7x200 + 1x100 (Opción A)

7x200 + 1x100 (Opción B)

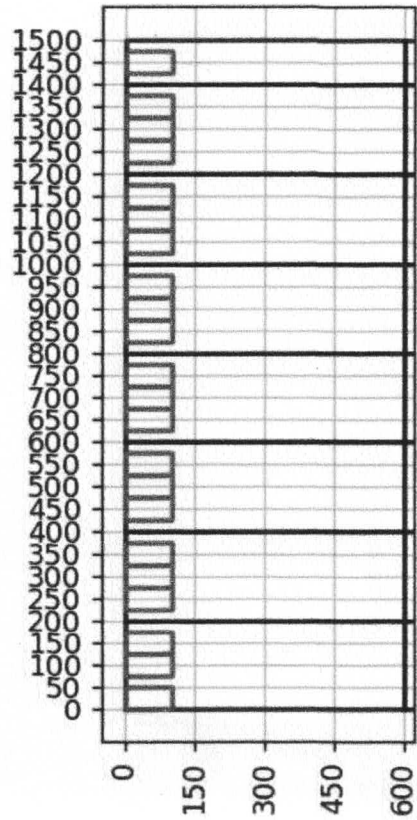
| Viga | Pos. Origen | Pastel | Comentario |
|------|-------------|--------|---------------|
| 22 | 1425 | 100 | Bloque de 100 |

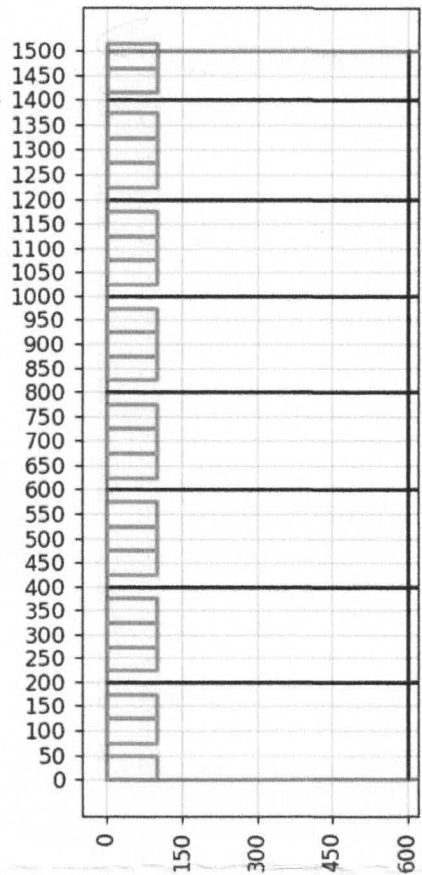
Requiere ajuste manual
y seteo "DB"

| Viga | Pos. Origen | Pastel | Comentario |
|------|-------------|--------|----------------------|
| 23 | 1465 | 50 | Sobresale del bloque |

Hay un problema con la viga 23. Al
superar los 1450 no deja el espacio
para permitir la circulación

¿C y si malficó DB de referencia?

→ DB "L7". Beam, Beam [7]. Position
actual

1465 → → 1450
